RE: Surface Water Impact Assessment Review – Revised Subsidence Impacts on Wambo Creek and Stony Creek

In August 2014 Evans & Peck (now trading as Advisian) completed an assessment of potential subsidence impacts on Wambo Creek and Stony Creek in support of an application to modify DA 305-7-2003 to enable extraction of an additional longwall panel (Longwall 10A).

The layout of Longwall 10A has been revised to shorten the commencing end by 245 metres. This revised layout of Longwall 10A will be presented in the North Wambo Underground Mine Extraction Plan for Longwalls 8 to 10A.

Figure 1: Location of Wambo Creek and Stony Creek in relation to the 'Previous Layout' and the Extraction Plan Layout'

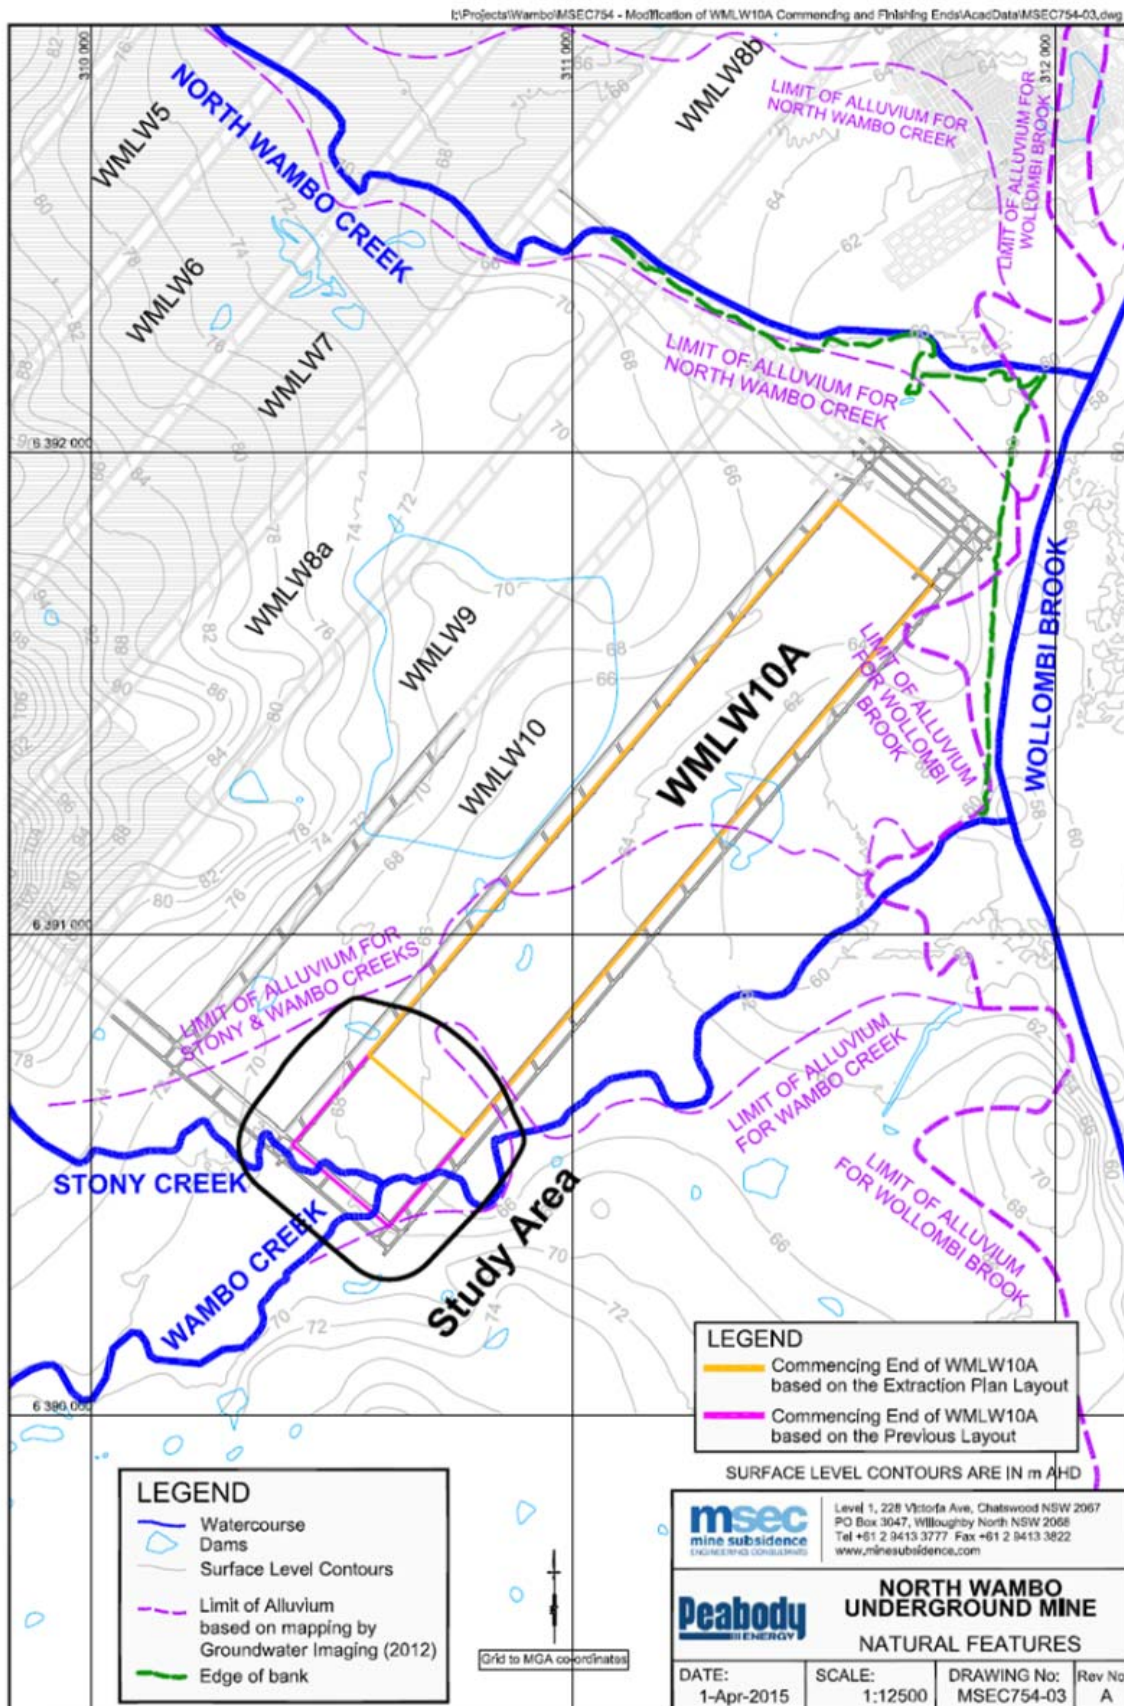
For the purposes of this letter report, the “Previous Layout” refers to the longwall layout presented and assessed in Evans & Peck (2014). The “Extraction Plan Layout” refers to the Longwall 10A with the shortened commencing end. The difference between the Previous Layout and the Extraction Plan Layout (i.e. the current layout of Longwall 10A) is shown on Figure 1 (attached at the end of this report).
